**ORDER: AUTHORIZE PROPOSED CHANGE ORDER #15 FOR THE NEW
LAFAYETTE COUNTY SHERIFF'S DEPARTMENT TO ADD CEILING-MOUNTED
BIPOLAR ION GENERATORS IN THE EVIDENCE STORAGE ROOMS**

RE: A New Sheriff's Department Building
and Improvements at the Detention
Center— Phase 2 (Rebid 2)
Lafayette County Board of Supervisors
PCO #15 – Add Bipolar Ion Generators in Evidence Storage Rooms

Change Proposal 015- Revised

RFP NO. 9

2 Basement B1 Reflected Ceiling Plan
A1:2 SCALE 1/8" = 1'-0"

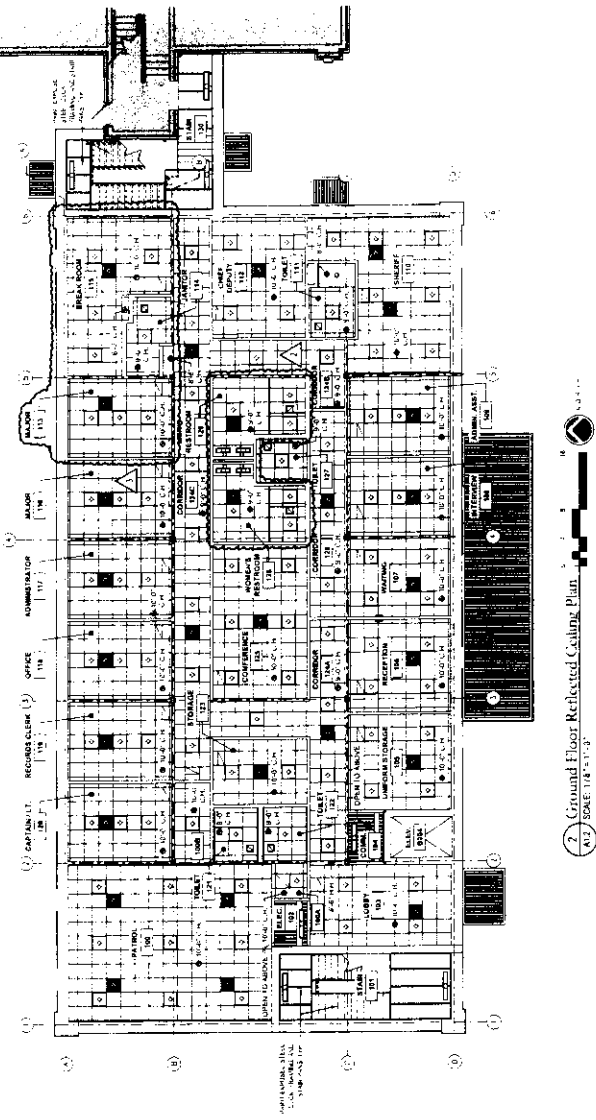
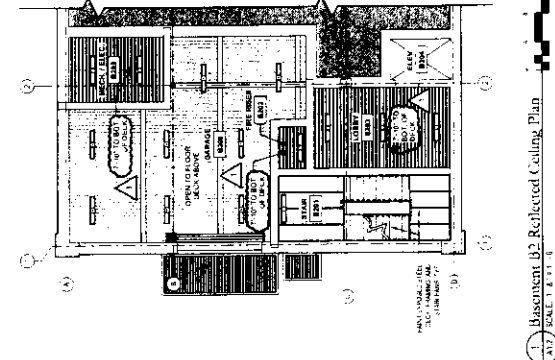
Item No. 1 — Furnish all materials and labor required to add (3) GPS Air IDF-2 ceiling-mounted bipolar ion distribution fans (or equal) in Evidence Storage B19 and Evidence Storage B06, as indicated on attached cut sheets, Sheet A1.2 revised on 3/24/25, and Sheet E3.0 revised on 4/1/25.
